Re: Response to Completeness Letter to Olof & Elizabeth Carmel dated July 5, 2011

# Preliminary Construction Management Plan for Carmel Gallery on Lincoln Ave August 3, 2011

Attachment 1: Photos showing current screening from Lincoln Avenue towards the southerly wall.

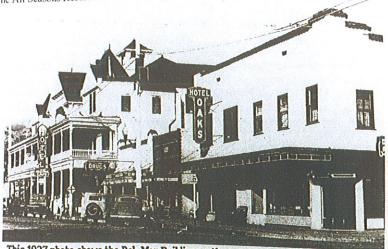
Comment #3: The south elevation needs additional architectural treatment to add visual interest to this expansive wall.

**Response:** The majority of this wall will be screened by trees, the Bank of the West building, and a fence and is therefore not visible to the public. Historic commercial architecture of this period often utilized similarly plain sidewall treatments, unique from the street façade. Our proposed building will dramatically improve this area because the real eyesore is the huge blank expanse of wall on the Sugar Daddies building. Our building will completely remove this wall from public view. Please see the attached photo of the existing wall. We plan to establish Ivy on this wall to provide a natural vegetative cover and further screening.

EAST ELEVATION QUATREFOIL
1329 LINCOLN AVE., CALISTOGA
50ALE: 1"=1-0" 7-31-11

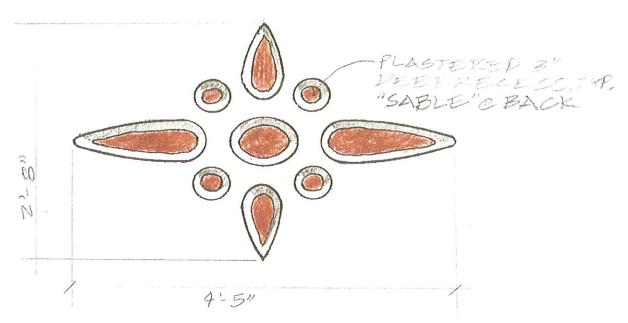
Comment #5: Additional information is needed on the material / color of the decorative element above the balcony roof projection on the east façade.

Response: The quatrefoil proposed is a traditional element in the gable design of the Spanish Colonial Revival style. This specific design is a unique composition that splays out on a horizontal axis in order to compliment the overall proportion of the façade. It is essentially a plastered relief carved sculpture that will be hand carved by the plasterer's on site utilizing a custom prepared template as a guide. There will be a recessed area in the wall framing to allow for its depth. It will have a back depth of three inches from the face of the stucco wall plane, thereby being deep enough to allow for shade patterns to travel across it through the hours it receives sunlight. It's back will also be stucco, but in the contrasting color of Sable to compliment and coordinate with the buildings' window and door frames. The hand curved sidewalls of the relief carving will be same color as the primary wall color, Oatmeal. Please see the attached sketch also.
